**U.S. Army Corps
of Engineers**
Engineering and Support
Center, Huntsville

Large Consolidated Fire, Safety, and Security Headquarters Facility

**Building 20709
Fort Bliss, TX**

**POTR – Phase 1
Project No 64608**

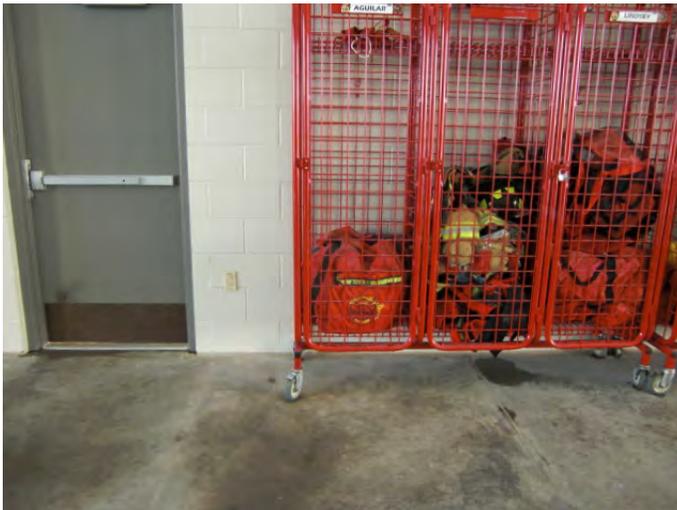
- Kitchen needs 2 refrigerators, not 1 refrigerator and 1 freezer. Actually needs a refrigerator for each Company (i.e. a 3-Company station would need 3 refrigerators).
- Look at security of the detention area. Should there only be one door into that area, and should it be provided with a vestibule?
- Look at stained concrete floor in MP and guard area. VCT is not holding up well and is marking from all the traffic.

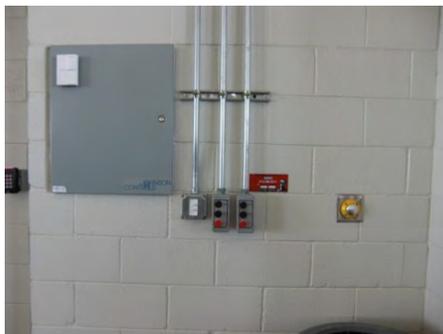
- The transformer is metered.

- Does the transformer meter, gas meter, and water meter appear to be connected to the Building Monitoring System? This information will be provided later.
